STATE OF NORTH CAROLINA
DEPARTMENT OF TRANSPORTATION

Addendum No. 1

Contract No.: DA00134

Milling, Resurfacing and Longlife Pavement Markings on US17 (Ocean Highway)

PROJECT REFERENCE NO.	SHEET NO.
45078.3.ST1	6
RW SHEET NO.	
ROADWAY DESIGN ENGINEER	HYDRAULICS ENGINEER

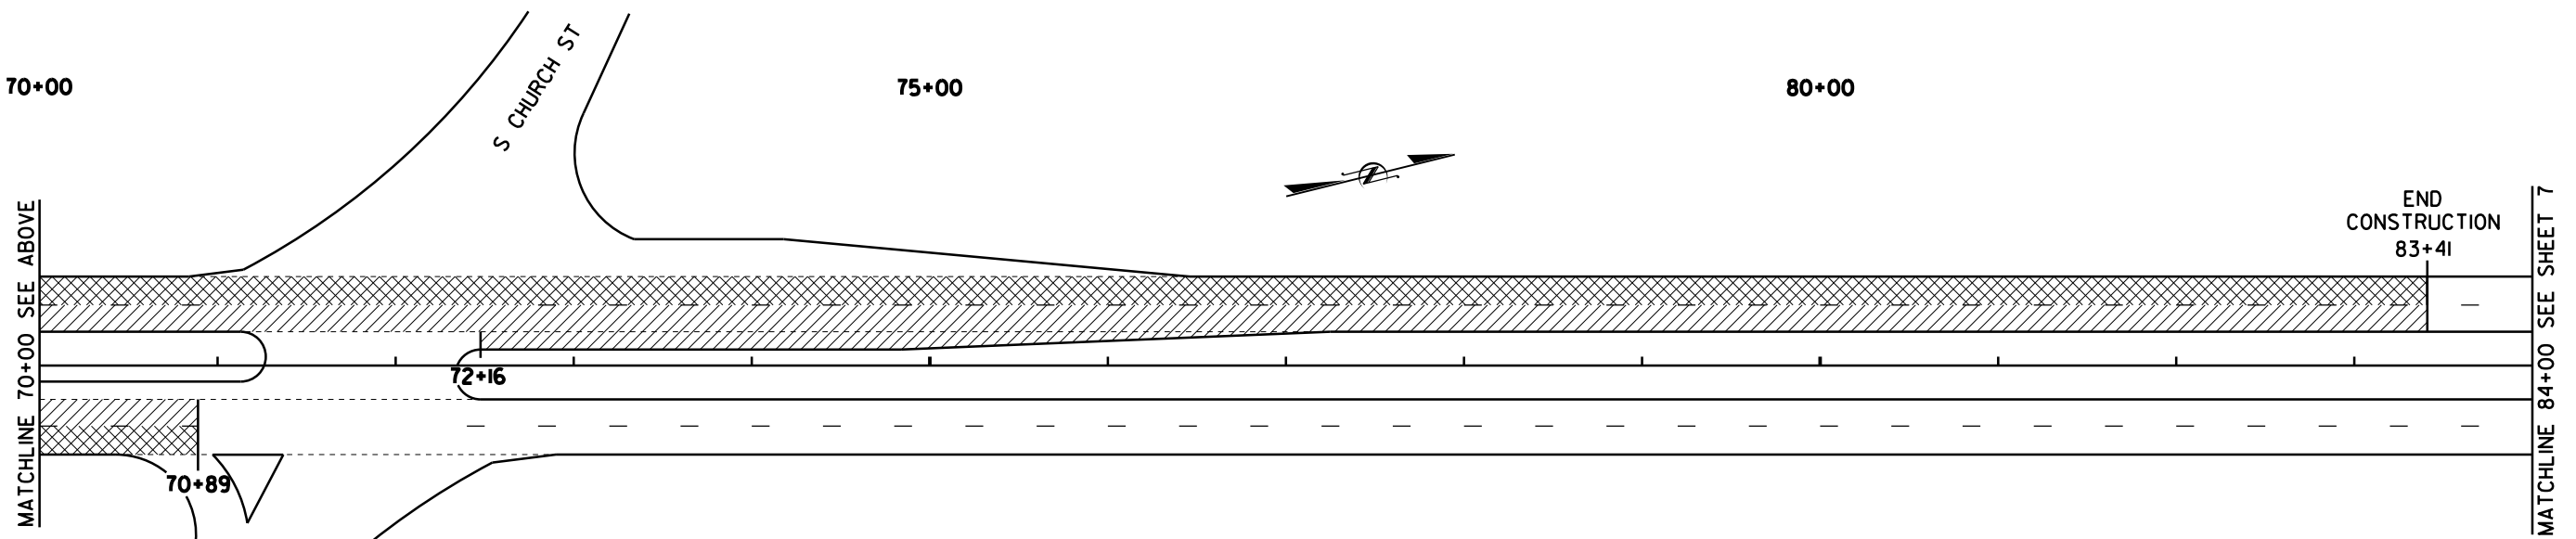
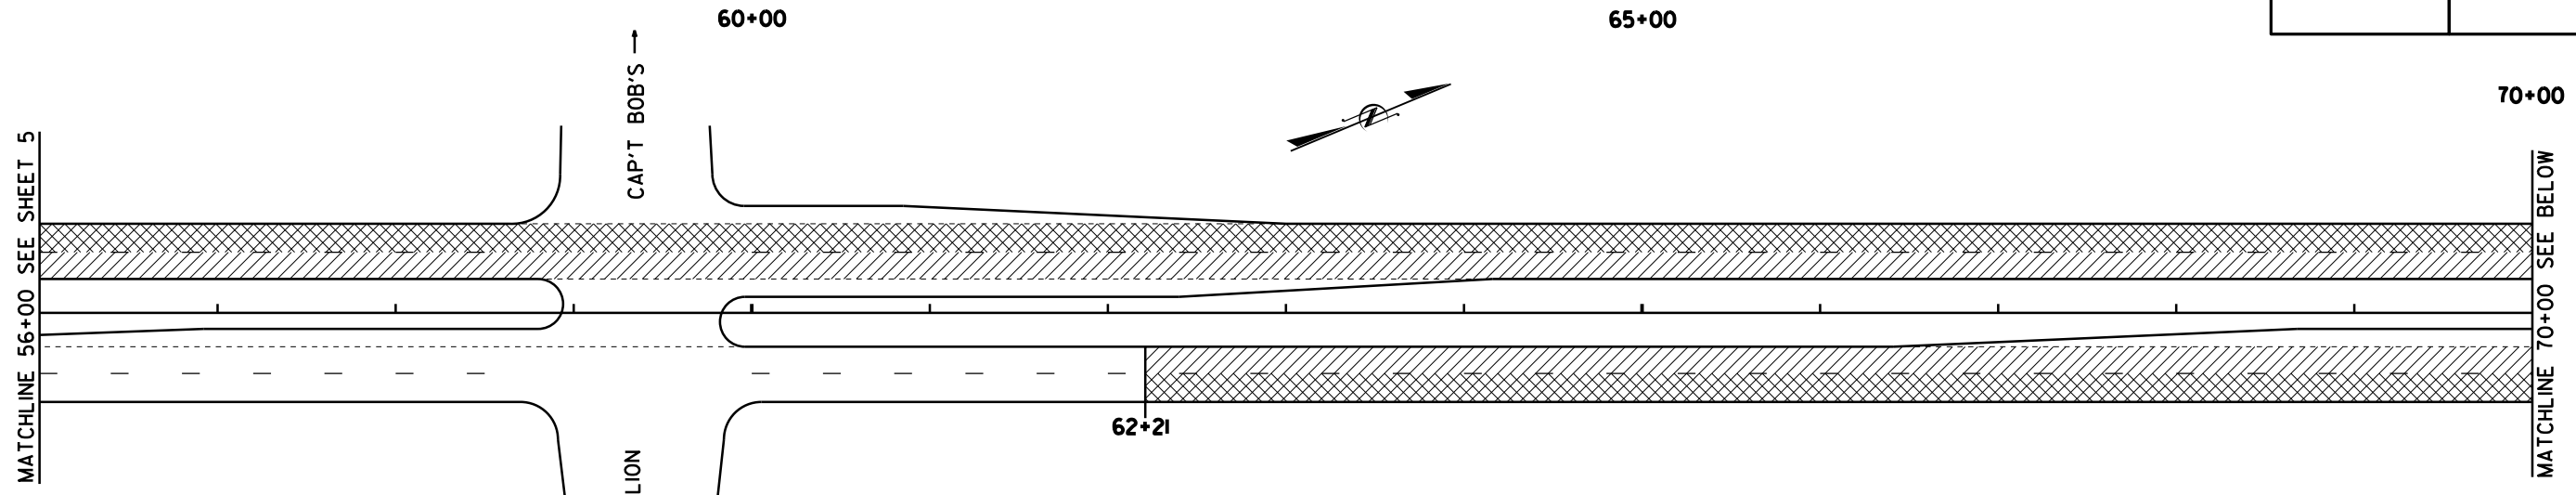
Plan Sheet #6 has been revised to properly illustrate the required work and match the Typical Section. Please void the existing Plan Sheet #6 and staple the revised Plan Sheet #6 thereto.

-  1.5" MILLING, 1.5" OF ACSC S9.5C
-  3" MILLING, 3" OF ACSC S9.5C (2 LAYERS, EACH @ 1.5")
